Notice of Allowability

10/736,930

SAMIE ET AL.

EXAMINER'S AMENDMENT

FIG. 2

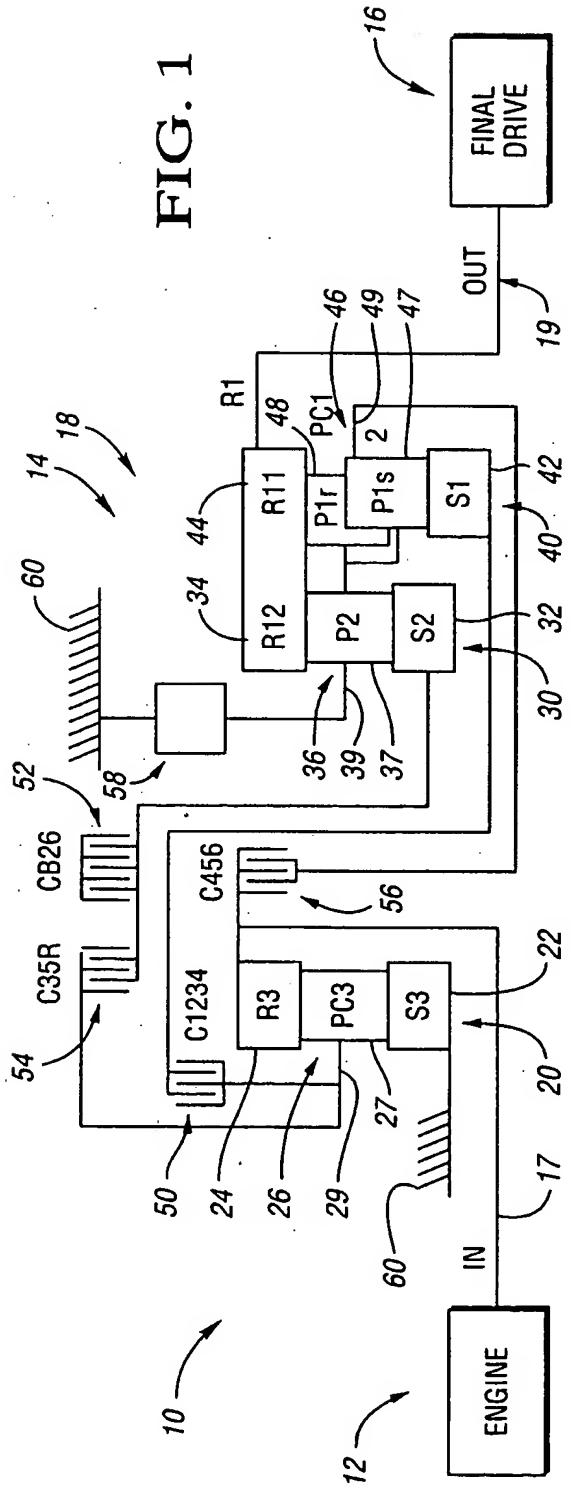
- The following changes to the drawings have been approved by the examiner and agreed upon by applicant:
 - FIG.2, “MECHANICAL DIODE (58)” has been amended as --
SELECTABLE BRAKING ONE-WAY CLUTCH (58)--.

In order to avoid abandonment of the application, applicant must make these above agreed upon drawing changes. See attached FIG.2.
